Product Change Notice

PCN #: BE090220

Re: High Boost HAM

HAM Derating

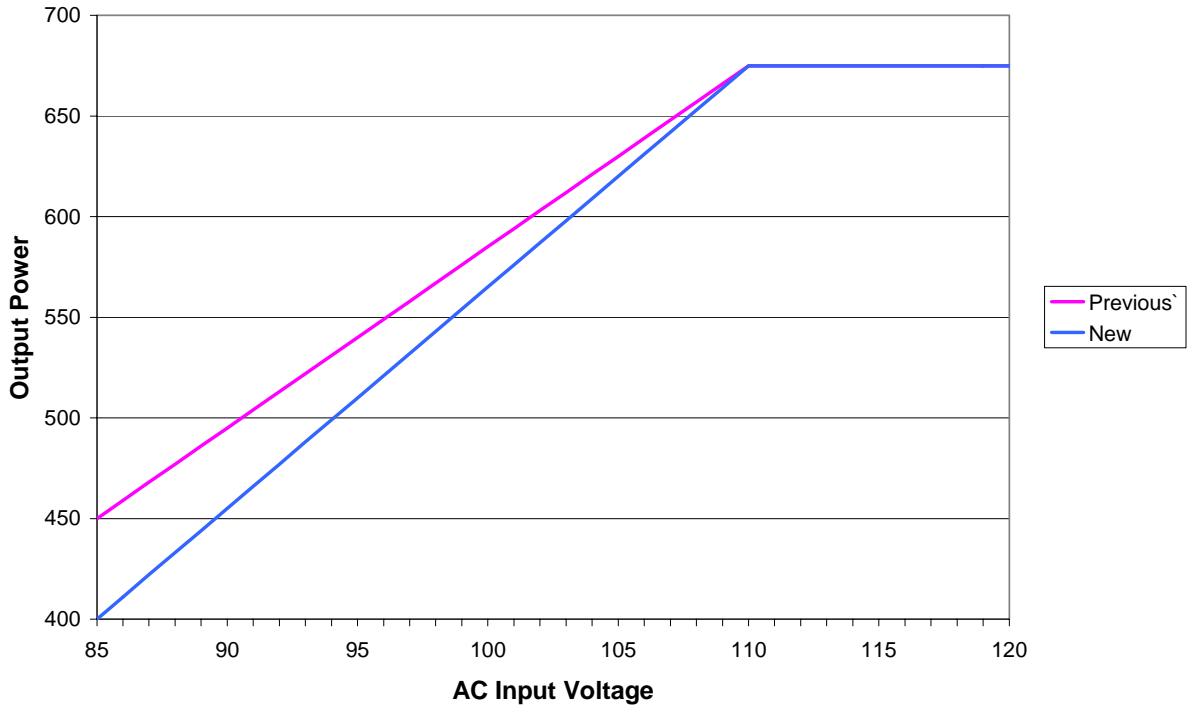
The high boost HAM power de-rating below 110Vac has been changed from 9 watts/Vac to 11 watts/Vac (see attached chart). This results in a power reduction throughout this range with the maximum reduction at 85Vac. At 85Vac, maximum power has been reduced from 450W to 400W.
